Product Change Notification - SYST-16NCFL501

ERRATA - SAM G55 Series Family Silicon Errata and Data Sheet Clarifications

**SAM G55 Series Family
Silicon Errata and Data Sheet Clarification**

8. Module: USART - Transmitter Operations

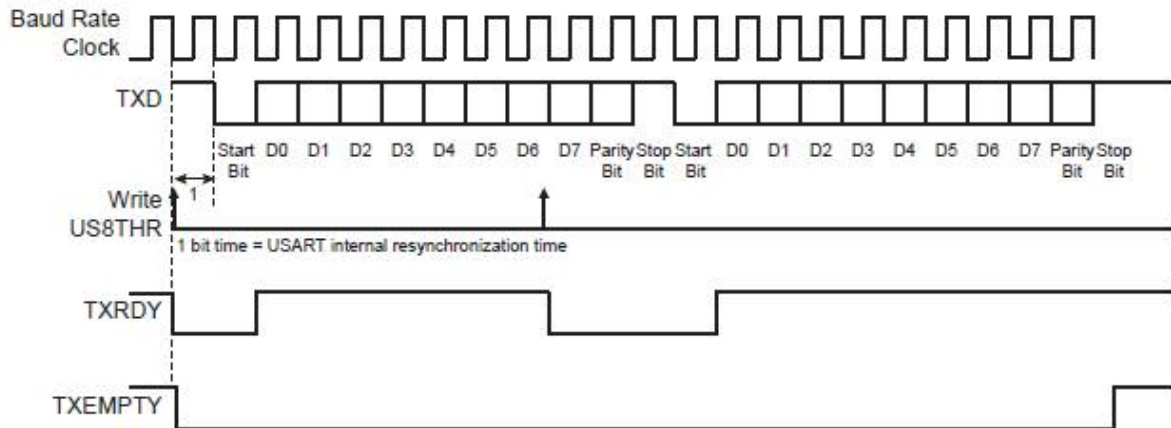
Figure 30-6 is incorrect. The corrected figure is as shown below:
